Interactive comment on “Estimating net anthropogenic nitrogen inputs (NANI) in the Lake Dianchi Basin of China” by W. Gao et al.

Received and published: 17 June 2014

Fig. 1.

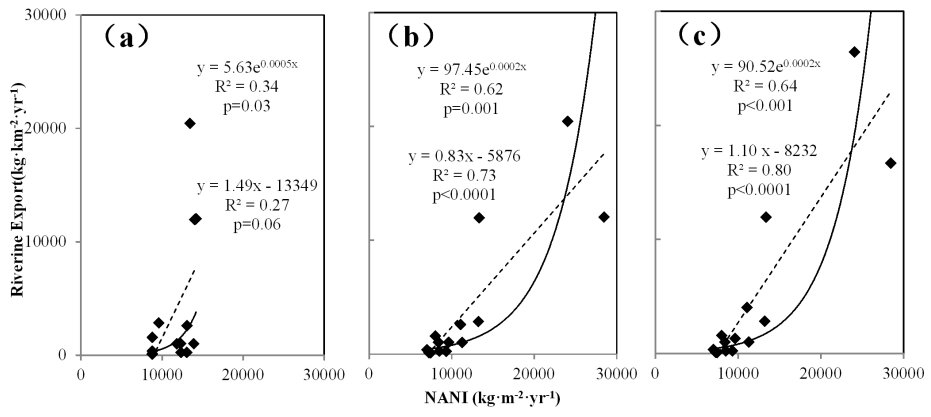
(1) “In abstract and conclusion, you mentioned the negative intercept of Fig 5 implying the consequences of massive pollution controls in those watersheds. The negative intercept actually suggested the existences of the threshold values of NANI for the watershed N retention around 10,000 kg/km²/y, but I couldn't find any other strong evidences to indicate the role of pollution control on riverine N export in those watersheds. I recommend deleting those discussions on the influence of pollution control.”

Authors' response: We agree that more evidences should be provided to demonstrate the role of pollution control on riverine N export. The influence of pollution control (e.g. sewage treatment plants) on riverine N export in the basin was assessed by comparing the differences in the relationship between NANI (net anthropogenic N inputs) and riverine export by comparing the effect of including and not including the estimated N reduction from sewage treatment plants. A new figure (Fig. 5c) was supplied to show the difference. The result shows that adding the N removed by treatment plants to the riverine N export would significantly improve the relationship, i.e. that the effect of the N removal is to weaken the linear relationship between NANI and riverine N fluxes.

Therefore, we believe pollution control is an important factor in analyzing riverine N export, particularly in small, populous watersheds. In Page 4136, we added a new graph “To assess the effect of the N removal on riverine N export, N removed by the six sewage treatment plants (Fig. 7) was added to the riverine N export in the affected watersheds. According to the drainage area of each sewage treatment plant, N removed by sewage treatment plants 1, 4, and 5 was added to riverine N export in watershed 12 while riverine N export in watershed 4, 5, 14 was revised by N removed by sewage treatment plants 2, 6, and 3 respectively. A new relationship between NANI and revised riverine export is developed (Fig. 5c). Compared with conventional method (Fig. 5b), a higher R² was found in the adjusted function ($p < 0.0001$). Furthermore, the statistical significance of intercept is better ($p < 0.005$). It is clear that the effect of the N removal is to weaken the linear relationship between NANI and riverine N fluxes. Therefore, we believe pollution control is an important factor in analyzing riverine N export, particularly in small, populous watersheds.
